Product Change Notification

Bourns® Model PQ2614BHA, PQ2614BLA and PQ2617BHA Series Shielded Power Inductors

Change to Mounting Platform Design and use of Epoxy

IC1828

Part Number	Platform	
	Current	New
PQ2614BHA Series PQ2614BLA Series PQ2617BHA Series

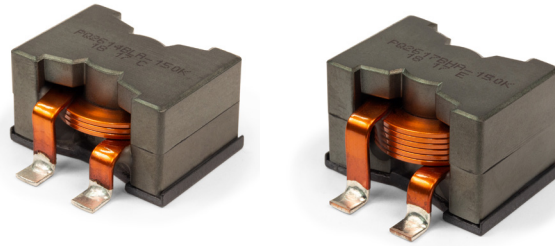
Effective immediately, Bourns is changing the mounting plate design to include a protruded edge to the left, right and back side of the platform and also grids to the surface. These changes will help enhance the inductor's ability to withstand mechanical shock, vibration and increase adhesion strength between the platform and the inductor's core. The use of an adhesive material throughout the inductor assembly is also changing from a 2-part epoxy to a 1-part epoxy for a simplified manufacturing process.

The change to the mounting platform design will affect the inductors' form. The fit and function remain unchanged. The quality and reliability of the inductors should be improved. The change to the use of epoxy will not affect the inductors' form, fit, function, quality or reliability. Affected part numbers are shown on page 2.
